GE Hitachi Model No. 2000 Package RAI Discussion

Teleconference
July 1, 2015

Agenda

RAI 2.2 Propose Response cont'd:

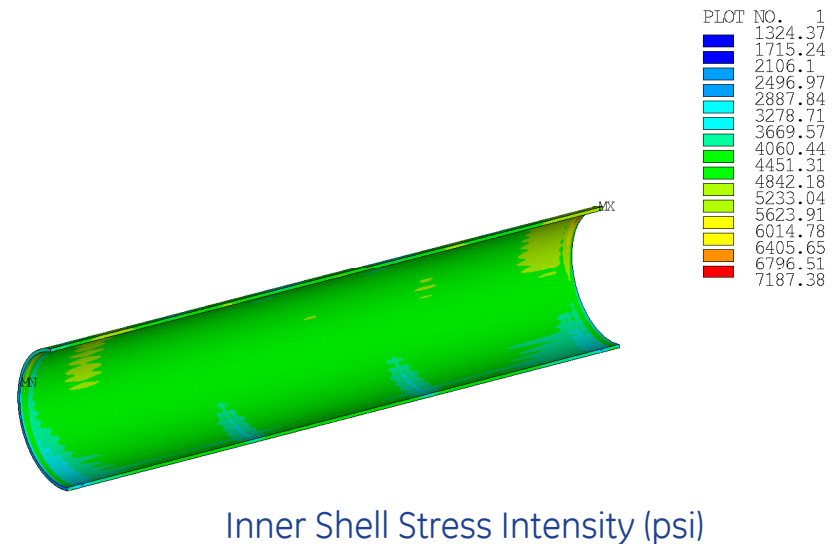
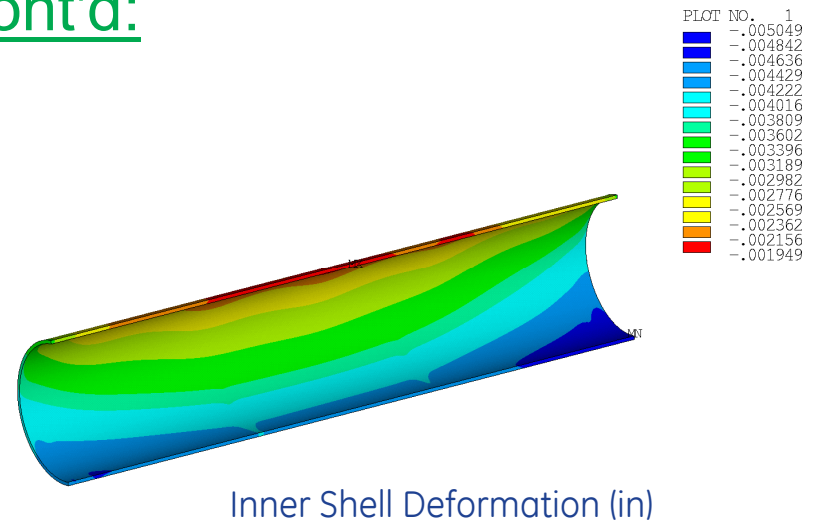
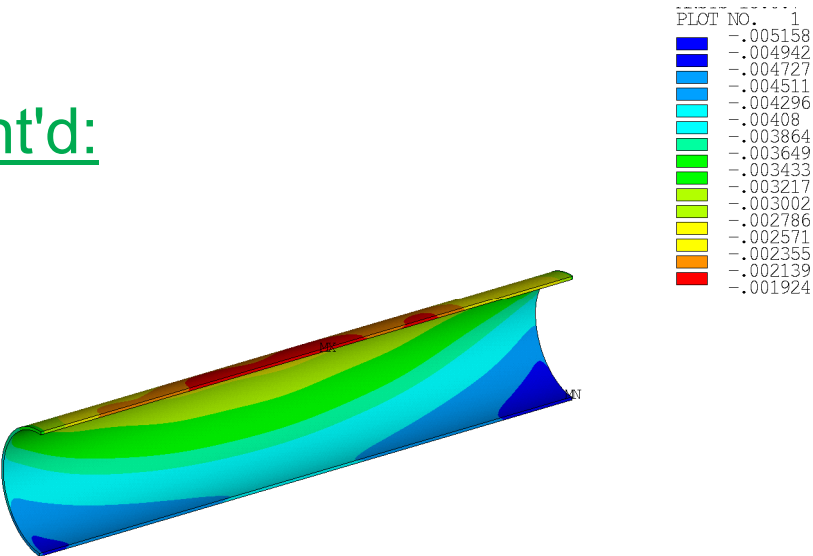
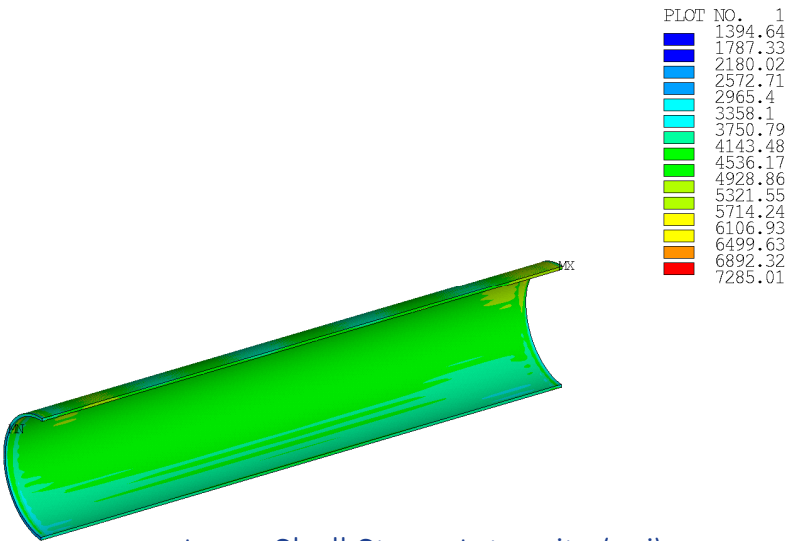
Justify the uniform equivalent static pressure assumption, along the High Performance Insert (HPI) axis, to represent the inertia load produced by the loaded Material Basket in determining margins of safety. If a line load assumption is considered, identify the stress acceptance criteria and corresponding margins of safety for the inner shell of the HPI subject to the normal conditions of transport (NCT) side-drop tests and conditions.

In Section 2.6.7.5, Boundary Conditions, drawing 001N8424 shows that the Material Basket is laterally supported by [[
]]. As such, contrary to the “area load” distribution assumption, the HPI inner shell is expected to be subject to a “line load” at each of the [[
]].

Two study runs were performed to show the difference between 4 line loads that represent the basket in contact with the HPI inner shell and a uniformly distributed load along the length of the basket.

Preliminary results show that the uniform pressure case results in a slightly higher stress than the 4 line load case (7285 psi versus 7187 psi). Review of the displacement results shows that the stresses in the inner shell are following classic beam theory.

A third study run will be performed to concentrate the load further at the center of the inner shell to determine if the trend continues.

Inner Shell Deformation (in)

Inner Shell Stress Intensity (psi)

Figure 3.1-1. Temperature-history of the Cask Ports for HAC

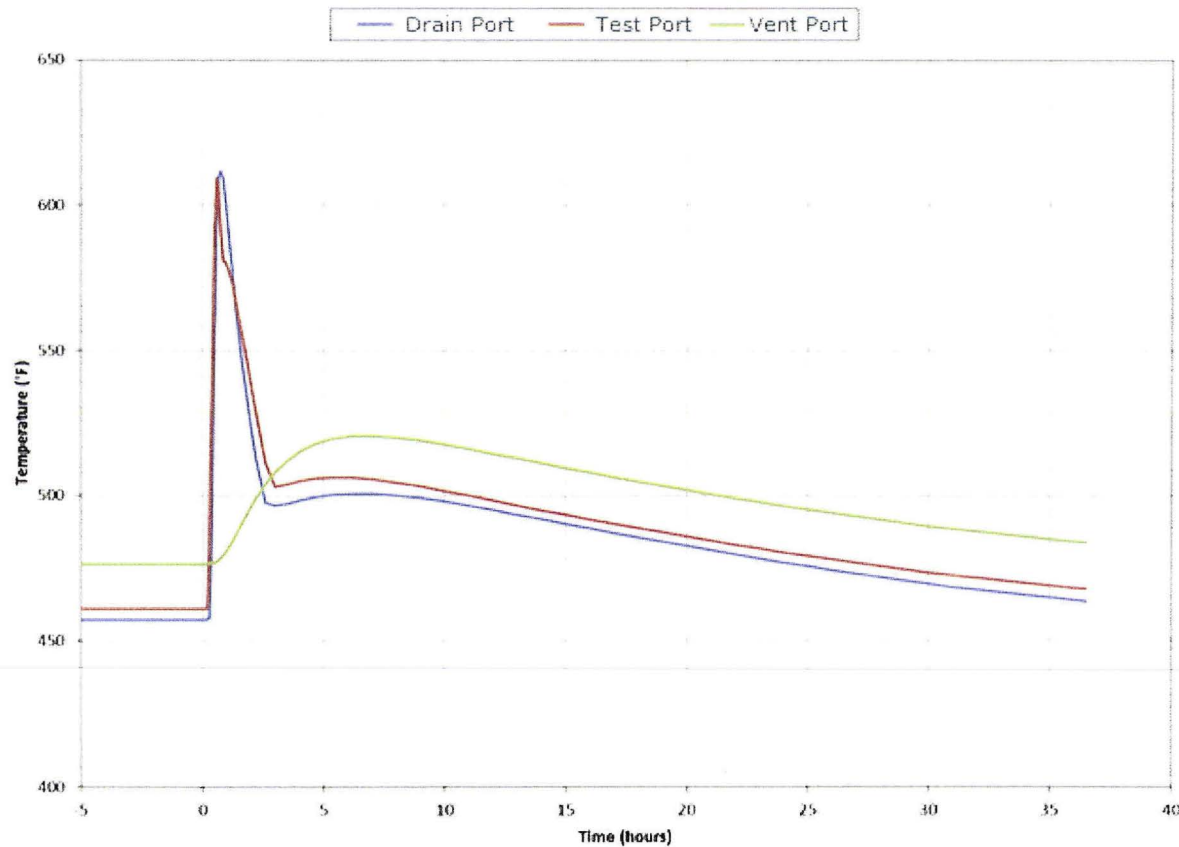
Provide the maximum temperatures of the O-rings located at test port, vent port and drain port, separately, under NCT and HAC.

As stated in SAR 1.2.1.1, GEH-2000 package has O-rings (made of [[
]]) installed at the test port, vent port, and drain port. Instead of listing one “single” maximum temperature of cask seal in SAR Table 3-4 for hypothetical accident conditions (HAC) and Table 3-12 for NCT, the applicant needs to provide the maximum temperatures of the O-rings located at test port, vent port and drain port, separately. This information is necessary to confirm that the temperatures are in fact below their design limits under NCT and HAC. This information is needed to determine compliance with 10 CFR 71.71 and 71.73.

Per RAI 3.2, the 3000 watt thermal analyses previously presented in the application are updated to address the HAC analyses use of forced convection during the 30-minute fire, a radiation boundary condition emissivity of 0.9 during the 30-minute fire, and a radiation boundary condition emissivity of 0.8 during the post-fire cool-down. NCT sensitivity studies were also performed to evaluate the thermal performance of the package using boundary conditions applied as both steady-state and constant boundary conditions solved as a transient. Because the solutions are radiation-dominated, the transient solution results in better convergence and slightly higher temperatures. To achieve steady-state conditions, the transient solver is used with a simulation time of 2000 hours. The 2000-hour duration of the transient analyses is sufficiently long enough for the temperatures within the package to reach their steady-state values—that is, the temperature of a node within the package model doesn't change from one time step to the next.

Using this revised solution methodology, the maximum temperatures of the ports are determined for both NCT and HAC. Tables 3.1-1 and 3.1-2 provide the NCT and HAC results, respectively. Figure 3.1-1 shows the temperature time-history of the port during the HAC fire and cool down.

RAI 4.1 Proposed Response cont'd:

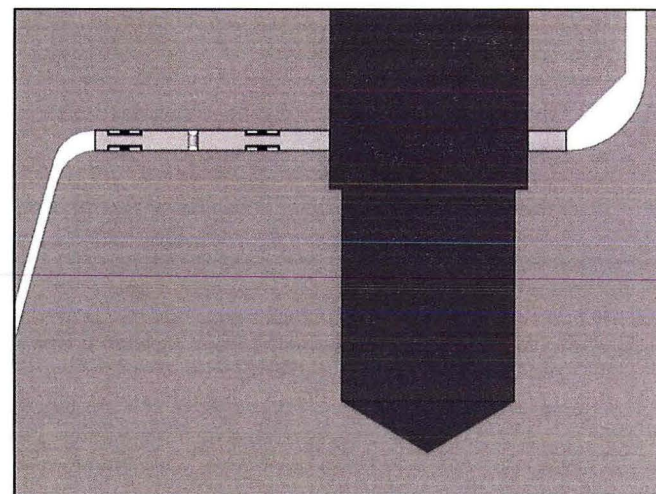
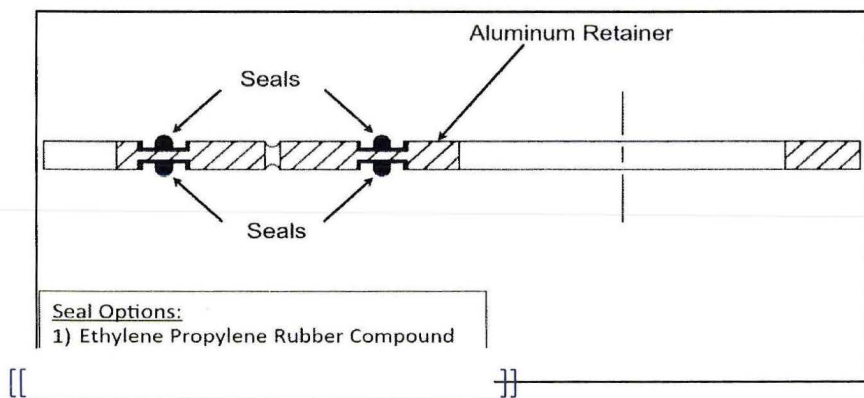
Provide the basis for the O-ring compression and O-ring groove dimensions in the drawings (i.e., from manufacturer data sheets).

The staff needs to verify the appropriateness of the seal for the containment system, therefore the basis for the O-ring compression and O-ring groove dimensions, such as from manufacturer data sheets, should be provided for the seals and the manufacturer and part number of the O-rings should be provided on the drawings.

The drawings should indicate both the dimensions and tolerances of the groove dimensions and the O-rings to ensure compression of the O-rings.

The dimensions and design for the “new” seals are identical to that of the seals that are currently licensed for the cask. For this application, the only change to the licensed seal design is a change of the [[]] material in the gasket seal and O-rings from the EPDM compound to the [[]] compound to accommodate the higher temperatures from the greater heat load. The information on the following two slides describes the gasket seal and O-ring designs that apply to both the old EPDM compound and the new [[]] compound.

In the currently approved Model 2000 seal design, there are no machined O-ring grooves in the Model 2000 cask body, but the cask is sealed using the Parker Gask-O-Seal design on the highly polished, flat-faced surfaces of the flanges on the cask body and lid. The Gask-O-Seal design for the cask consists of a 1/8 in. thick 6061-T6 aluminum retainer with two concentric [[]] seals on the top and two concentric [[]] seals on the bottom (4 total). The surfaces of the Model 2000 cask body and the lid flanges have an electropolished finish to ensure that they are clean sealing surfaces for the Gasket-O-Seal. The calculation inputs and results of preload requirements for gasket seating are included in NEDO-31581 in Sections 2.10.12.3 and 2.10.12.4, where it is determined that the preload is sufficient to seat the aluminum retainer of the Gask-O-Seal per the formulation presented in NUREG/CR-6007.

RAI 4.15 Propose Response:

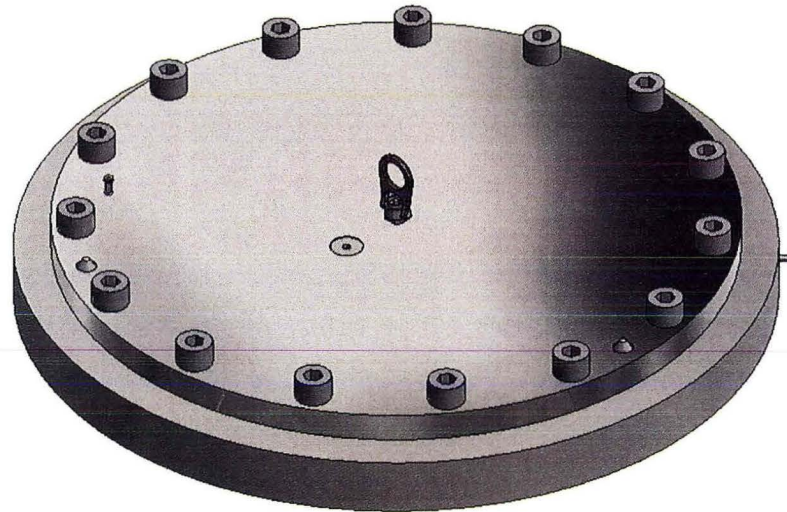
Research has shown that “Scale-model testing is not a reliable or acceptable method for quantifying the leakage rate of a full scale package” as noted in NUREG-1609 “Standard Review Plan for Transportation Packages for Radioactive Material” Section 4.5.3.2. The staff needs to verify that the seal testing method used in SAR Section 8.1.5.2 is acceptable.

The acceptance testing for the Commercial Grade Dedication of the [[]] Gask-O-Seal and O-rings will be on a full-scale model (in terms of seal and flange diameter), rather than a scale model as indicated in the letter authorization request, to ensure results are representative of the actual Model 2000 cask. Details of the seal acceptance tests will be provided upon completion of all tests.
